INDESIT company

INC310GAID

Commercial code:

52220a0 Exploded views

0522067: SEALS FOR DOORS FOAMED AS ONE PIECE

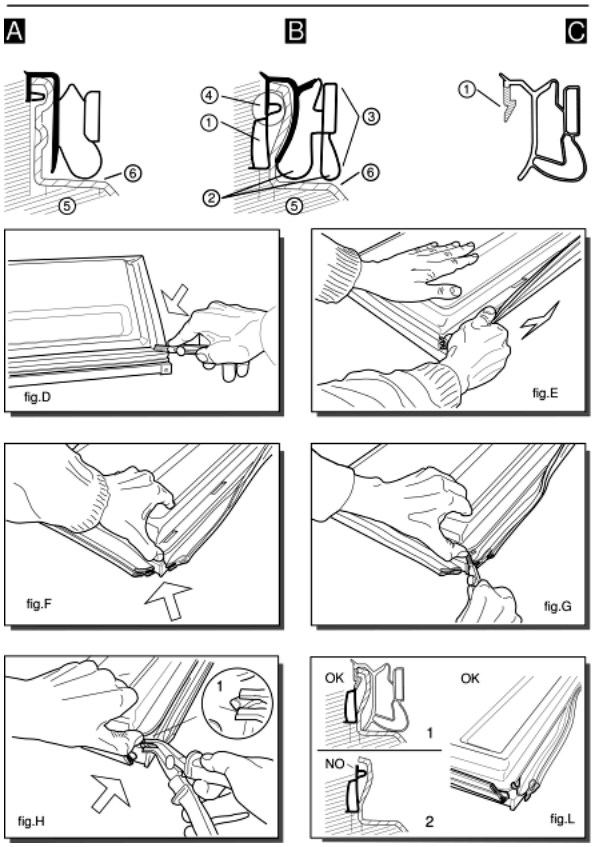
Various types of gaskets with different profile, as shown in figures (A) and (B), are used to fix the door (fig. A-5; B-5) and the inner door (fig. A-6; B-6) on the block foamed doors of combined freezers and refrigerators.
---Ilpea profile 245; 179; 412 (fig.A)
---Ilpea profile 287 (fig.B)
When replacing gaskets with profiles 245; 179; 412 these are fixed with screws (2 per corner) to the door.
Gaskets with profile 287 can not be used as spare parts but are designed to house the Ilpea type 900 gaskets (see figure C).
When replacing the gasket (287), once it is removed you will find a pocket (fig. B-1) between the door and inner door.
The rigid tooth (fig.C-1) of the gasket (900) is inserted inside between the pocket and the inner door, doing away with the need for screws.
Gasket with profile 287 is easy to identify since it has an exterior double edge (fig.B-2) which acts as a cushion when the door is closed.

To replace this gasket, follow these steps:
---Dismount the door and cut the four corners of the gasket along the joint (fig.D);
---lift the gasket and pull it carefully along its full length without tearing it (fig.E).
The purpose here is to detach the inner door slightly from the foam along the exterior edge for a depth equal to that of the gasket (fig.B-3);
---lift the corner of the inner door slightly, prising it up with your thumb (fig.F). Do not use a tool which might break the inner door;
---continue cutting the gasket inside the inner door for about 6 mm (fig.G);
---push in the tip of the pliers (type USAG N131) and pull outwards until you see the top edge of the pocket (fig. B-4) which is empty (fig.H-1);
---if you carry out this operation correctly (fig.L) you will be able to pull off the top edge of the pocket for the full length of the door.
If the gasket tears before the top edge (fig. L-2) you should repeat this operation from the other corner of the door.

---once the gasket (287), has been removed the space above the pocket (fig. L-1) can house the rigid tooth (fig. C-1) of the gasket 900.
When you fit this gasket ensure that it lies flush against the edge for the full length of the door.
If the rigid tooth is difficult to fit, eliminate any residues of foam between the door and the inner door in the gasket area.
fig.5131549A

n1030084: New sliding blocks for fixing the furniture door to the refrigerator door

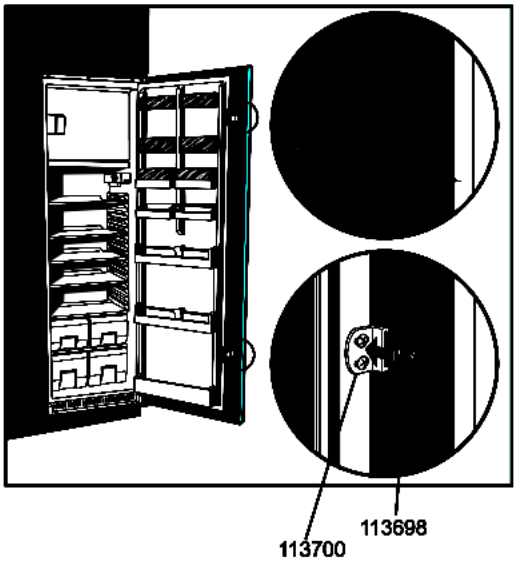
Since October 2004, the Carinaro factory has been using new sliding blocks for fixing the furniture door to the refrigerator door.
The new items are fixed to the side of the refrigerator door, whereas the previous ones were fixed to the front.
The doors are no longer provided with sixteen 2.6 mm holes on the front for fixing the old slides.
The new sliding blocks can also be fitted on premodification models. Proceed as shown in the attached figure (N1030084fig.1).
When replacing the sliding blocks on premodification models it will necessary to replace both guides.
This modification has involved changing the installation KITS

NB - Door spare part codes have not been changed.

New parts

113698 - LARGE NYLON HOLDER SLIDE
113700 - NYLON HOLDER SLIDING GUIDE

Installation kit (models with plastic slides)

C00113967 - REFRIGERATOR INSTALLATION KIT INC. 2/P 290L (10/2004)
C00113968 - REFRIGERATOR INSTALLATION KIT INC. 2/P 290L (10/2004)
C00113970 - REFRIGERATOR INSTALLATION KIT INC. 2/P 240L (10/2004)
C00113971 - FREEZER INSTALLATION KIT INC 1/P 200L (10/2004)
C00113973 - FREEZER INSTALLATION KIT INC 1/P 140L (10/2004)
C00113974 - REFRIGERATOR INSTALLATION KIT INC. 1/P 130L 10/2004)
C00113975 - FREEZER INSTALLATION KIT INC. 2/P 300/330L (10/2004)
C00113977 - REFRIGERATOR INSTALLATION KIT INC.1/P 230L (10/2004)
C00113979 - REFRIGERATOR INSTALLATION KIT INC.1/P 160L (10/2004)
C00113985 - FREEZER INSTALLATION KIT INC 2/P 300L (10/2004)
C00113986 - FREEZER INSTALLATION KIT INC 2/P 300L (10/2004)
C00113987 - FREEZER INSTALLATION KIT INC 2/P 240L (10/2004)
C00113988 - REFRIGERATOR INSTALLATION KIT INC.1/P 300L (10/2004)
C00113989 - REFRIGERATOR INSTALLATION KIT INC.1/P 300L (10/2004)

Parts replaced

021258 - SMALL WHITE SLIDE + COVER
021259 - WHITE SLIDE
